RE: Comment Response – Update 4  
218 South Lamar (SP-2019-0297C)  
218 S. Lamar Boulevard  
Austin, Travis County, Texas, 78704

We received the Master Comment Report U3 on December 10, 2020. The comments have been addressed and responses for the above referenced project are below.

③ FENCE DETAIL  
 1" = 1'-0"

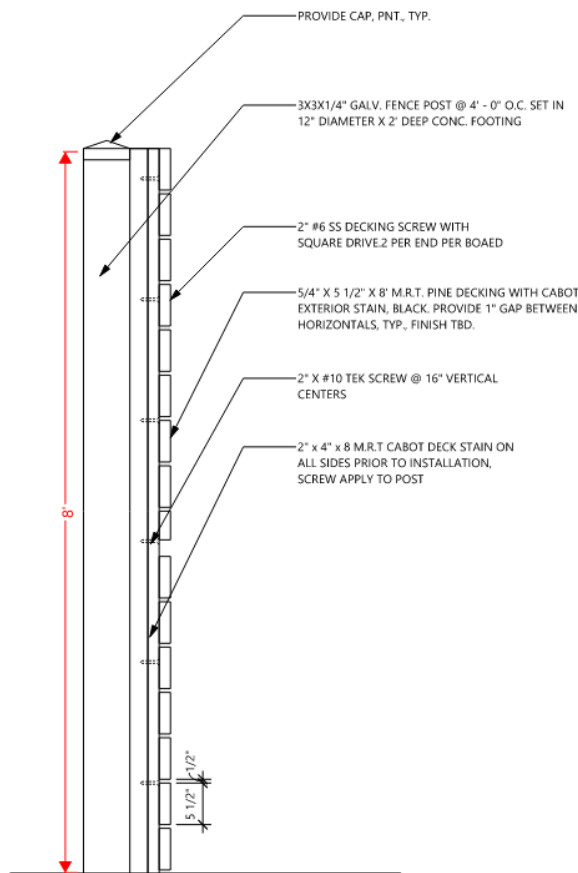
PR4. To comply with 25-2-721 (G), please provide evidence that air conditioning and heating equipment, utility meters, loading areas, and external storage are screened from public view.

**Update 4:** Represent and call out the screening/fencing, with the height, to show compliance with code.

The proposed site will have an 8-foot tall wooden fence along the western property line for screening. This fence is called out on the Site Plan (Sheet 9) and the architectural detail is included below for reference.

The electrical switchgear and transformer will be screened with switchgrass meeting the following criteria:

- **Mature height: 3.5' (2'-3' spread)**
- **Type of switch grass: common**
- **Perennial: Needs to be cut back to the ground in late winter to early spring**
- **Length of time before reaching maturity: 3 years**
- **Maintenance/irrigation plan: Drought tolerant, needs to be cut back every winter**

This equipment will also be screened by the staircase shielding the view from the north (as seen on Sheet 9), and the proposed building, shielding the view from the east at S. Lamar (as seen on Sheet 9). Each of these screened views is shown on the building elevations on Sheets 31 and 32.
